SERVICE BULLETIN

No. 498

Piper Aircraft Corporation

Inspection of Inboard Fuel Cell Vent Line Assemblies.

View Looking At Inboard Fuel Cell Vent Line Assembly (Left Shown - Right Opposite)

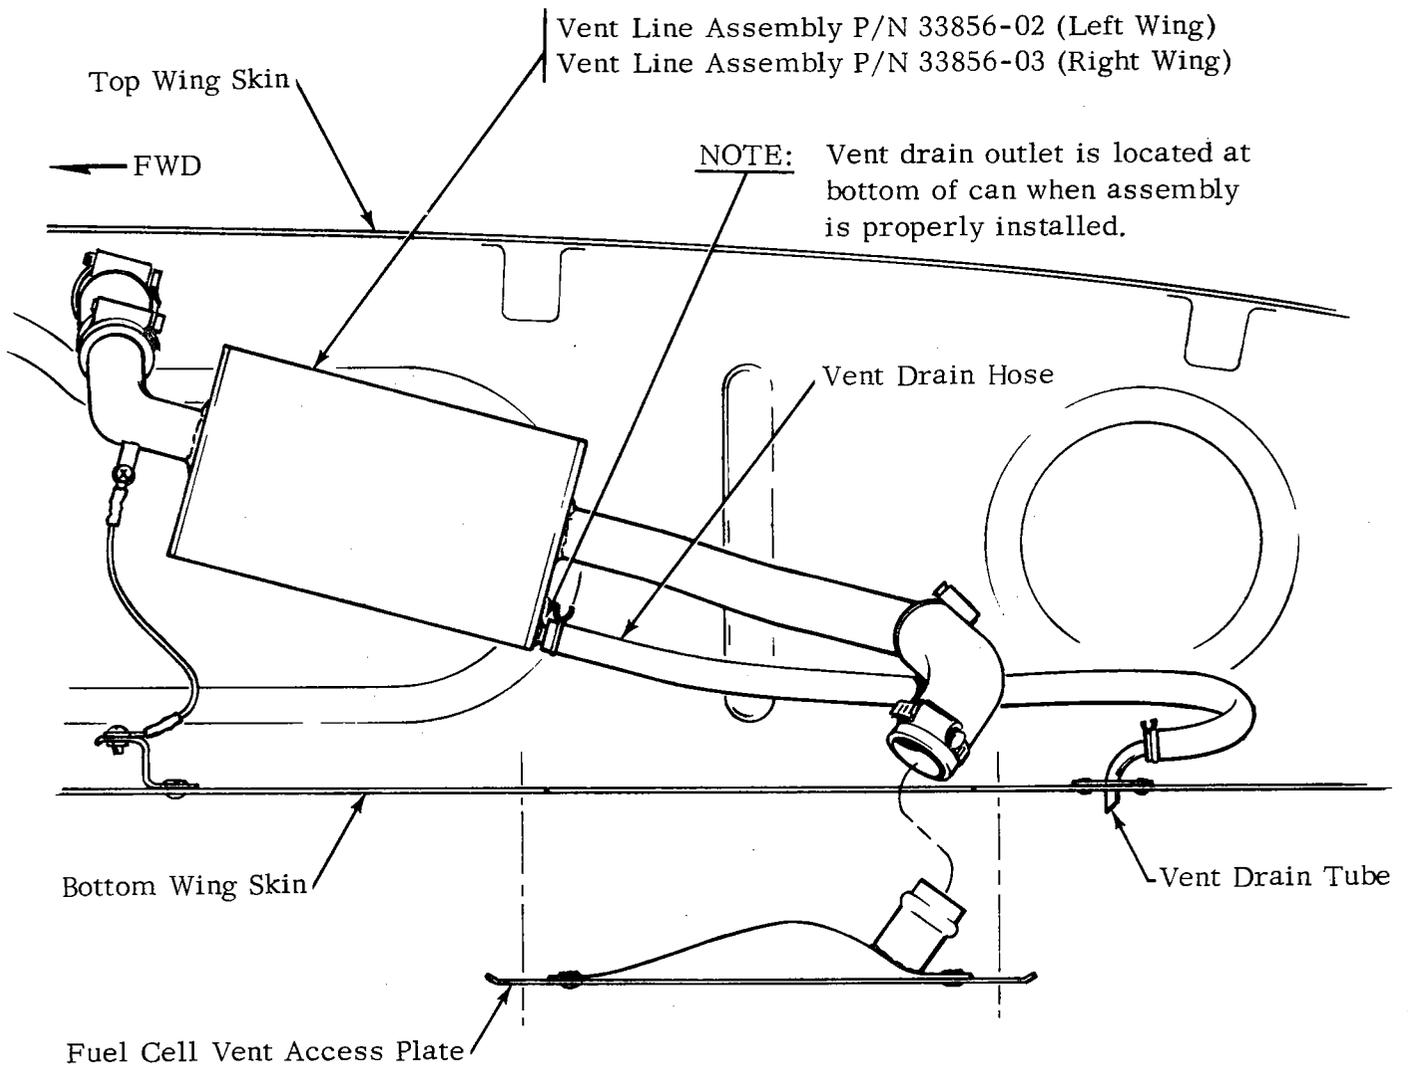
A recent condition was reported to the factory describing blocked Inboard Fuel Cell Vent Lines on one of the above referenced aircraft. It was determined that both Inboard Fuel Tank Vent Line Assemblies were installed in an inverted position, causing a "moisture trap" in a vent line. Further investigation revealed that this condition resulted from the left and right Fuel Cell Vent Line Assemblies being reversed during installation.

1. Remove fuel cell vent access plate from bottom of left and right wing skins to gain access to inboard fuel cell vent line assemblies.
2. Inspect vent line assemblies to determine if vent drain outlet is properly located at bottom of can as shown.
 - a. If inspection reveals that vent line assemblies are not properly installed, switch assemblies from one wing to the other. (The vent drain outlet must be located at bottom of can on both wings.)
3. Reinstall fuel cell vent access plates and make proper logbook entry of inspection.
